August 26, 2014

Travil Thul
Office of Engineering and Technology
Federal Communications Commission
Re: FCC ID: ZEH0414
Applicant: PLUS Location Systems USA, LLC
Correspondence Reference Number: 46280
Form 731 Confirmation Number: EA470317

Figure 2. UWB Packet. Each line is a 2 nanosecond pulse.

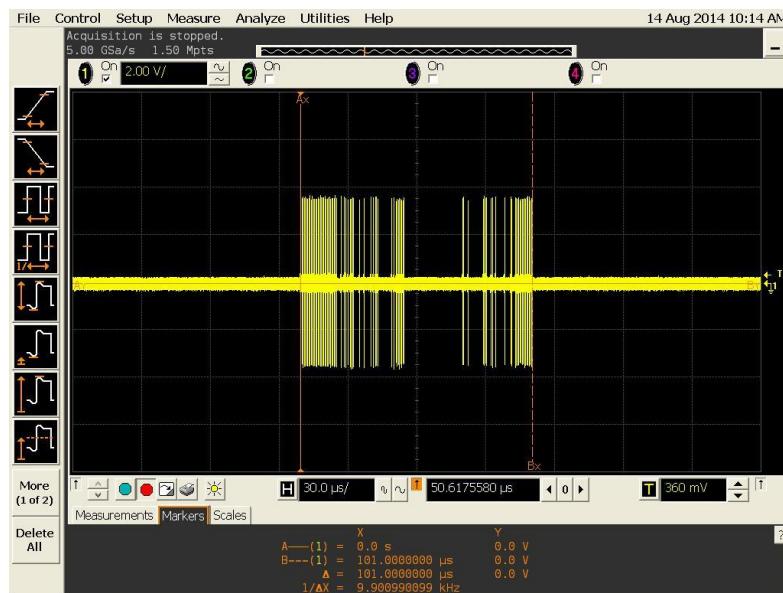
4) Per 15.519(a)(1), 'a UWB device operating under the provisions of this section shall transmit only when it is sending information to an associated receiver. The UWB intentional radiator shall cease transmission within 10 seconds unless it receives an acknowledgement from the associated receiver that is transmission is being received'. Please submit supporting documentation describing how this requirement is fulfilled.

The UWB transmitter operates as part of a system in which it sends short duration UWB packets to one or more receivers. The transmitter's cycle of operation is as follows: 1) the transmitter's microcontroller begins in a non-transmitting sleep state, 2) the transmitter transitions to an active state, in which it sends a short UWB packet of fixed duration of 101 microseconds, 3) the transmitter microcontroller ceases the transmission and returns to a sleep state.

An oscilloscope screen capture of the 101 microsecond packet is shown in the figure below.

Per the 15.519(a)(1) requirement, the UWB transmitter is allowed to operate up to 10 seconds after which it must cease its transmission if it has not received an acknowledgement from the associated receiver. As demonstrated, the UWB transmitter will automatically cease its transmission after only 101 microseconds, meeting the required behavior in much less than the allowed 10 seconds.
